4.2 S75W ADJUSTMENTS SCHEME ADJUSTMENT MASSING

4.3 S75W ADJUSTMENTS PROPOSED CONCEPT PLAN SCHEME

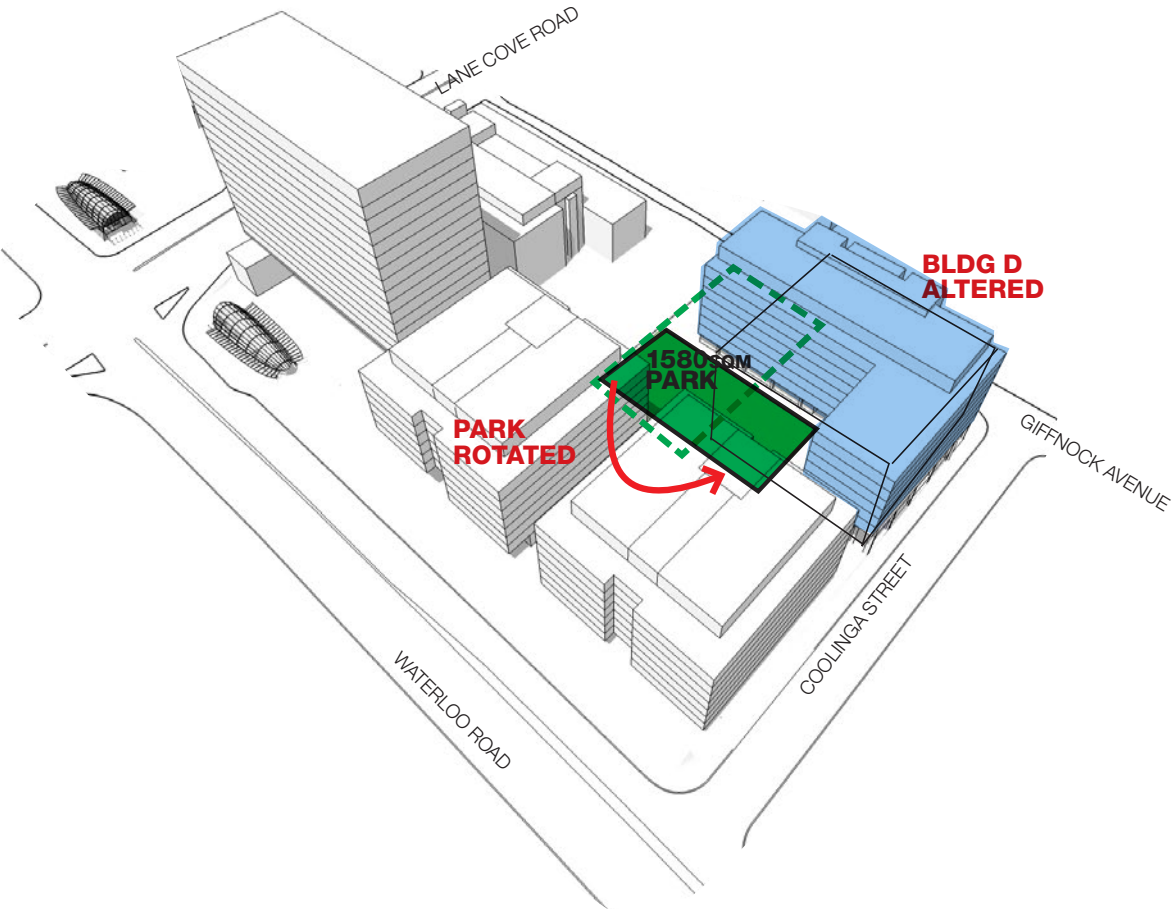
The following sequence describes the adjustments to the approved Concept Plan.

1. Station Plaza is increased by 6m in width to create a larger public interface between the precinct and the station.

Building A proportions therefore adjust to lengthen the footprint. Building separation is reduced to 9m between buildings A and B as well as B and C to accommodate plaza and create a more intimate & active laneway scale.

2. Through an altered Building D footprint the central open space of the park can be increased in size and be enclosed on three-sides to provide outlook from the office levels, provide increase retail edge condition at ground level that fronts the park.

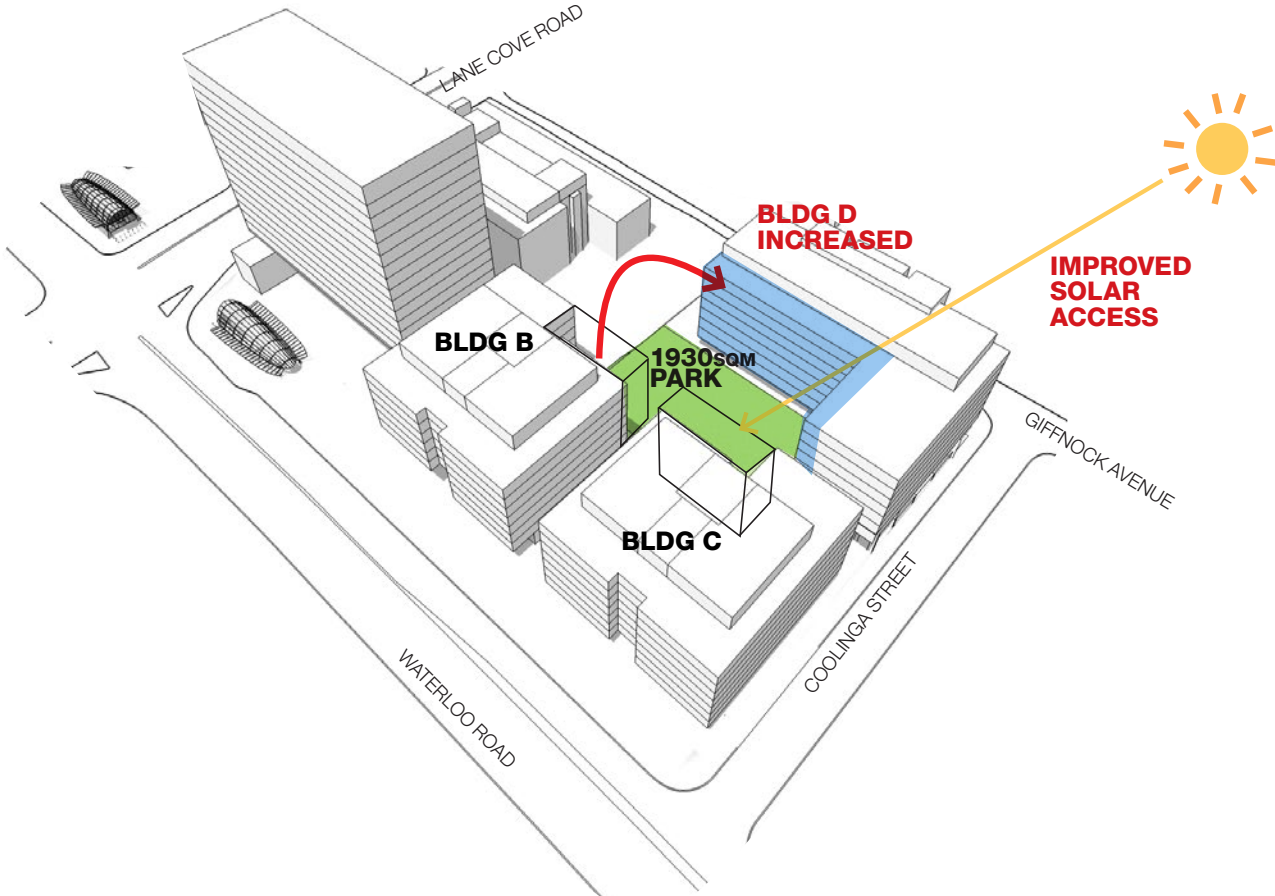
3. An area transfer from Building's B & C, the overshadowing impact on the park is significantly reduced as daylight access is increased throughout the year. The park is now inset into the Building B and C envelopes to further activate and integrate the open space.

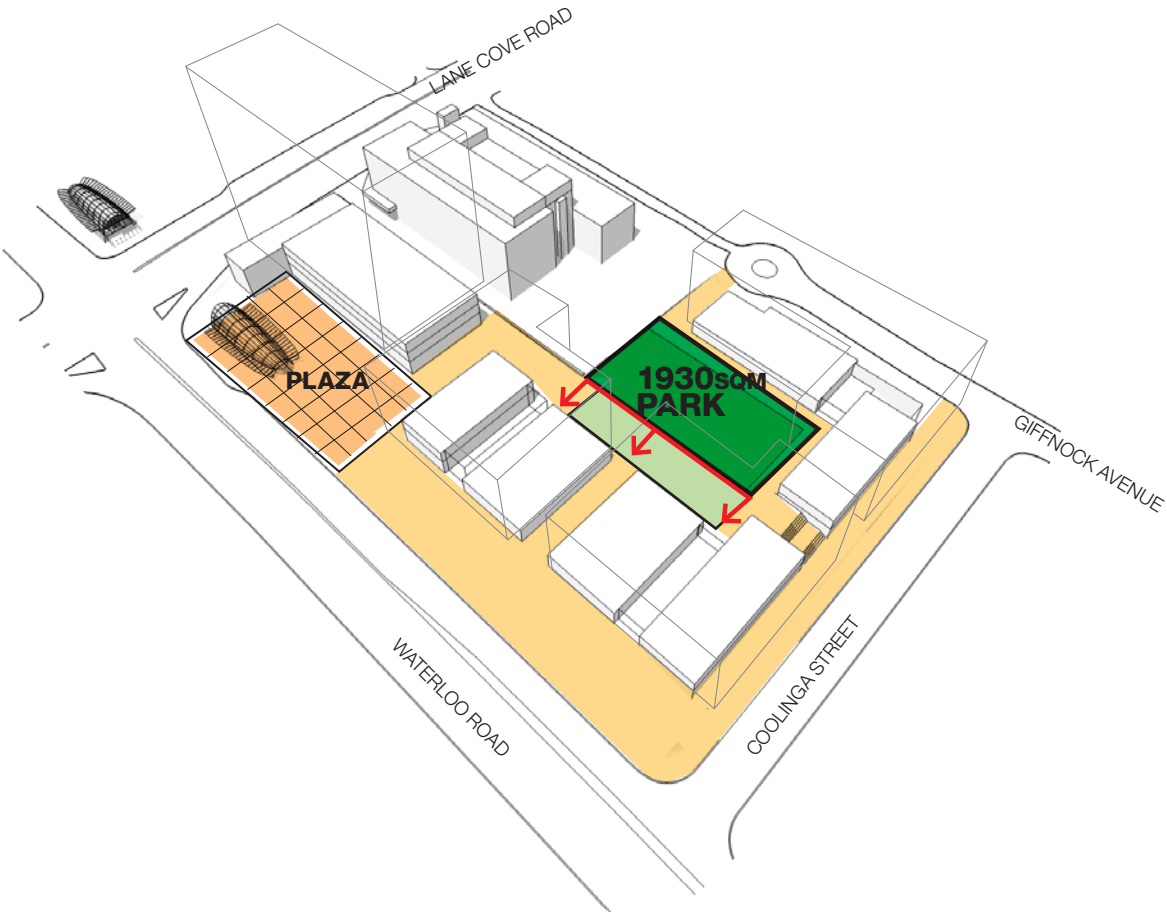
4. The changes have resulted in an increased park size. The park is now 1,930sqm an increase of 30% from the approval

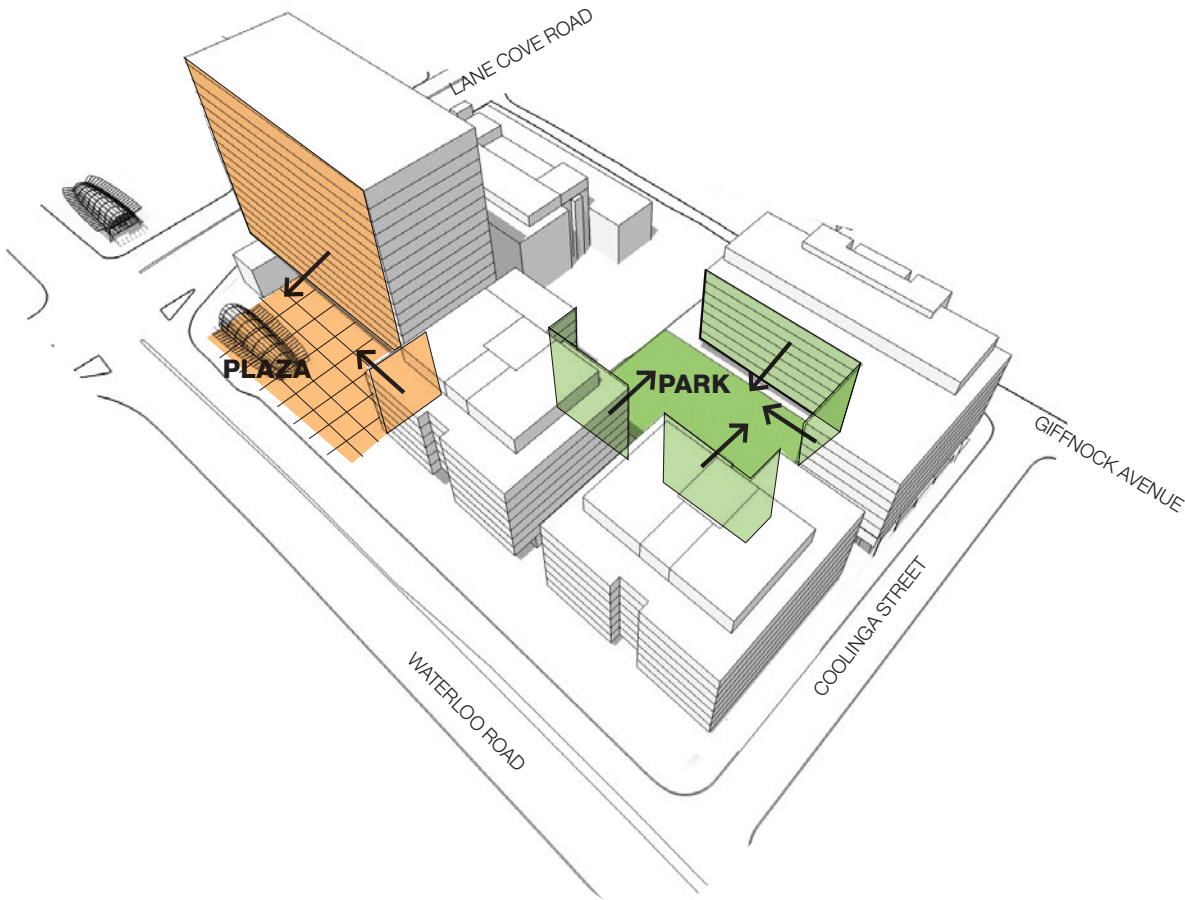
5. The alternate orientation for Bldg D and the area transfer creates a park with buildings to three-sides. Each building has opportunities for outlook over the park below. Increased facade to park also provides greater passive surveillance improving safety and security to the pedestrian through site links.
The increase of the size and proportion of the station plaza is the catalyst for these changes. This scheme presents a more usable public open space immediately adjacent a major train station.
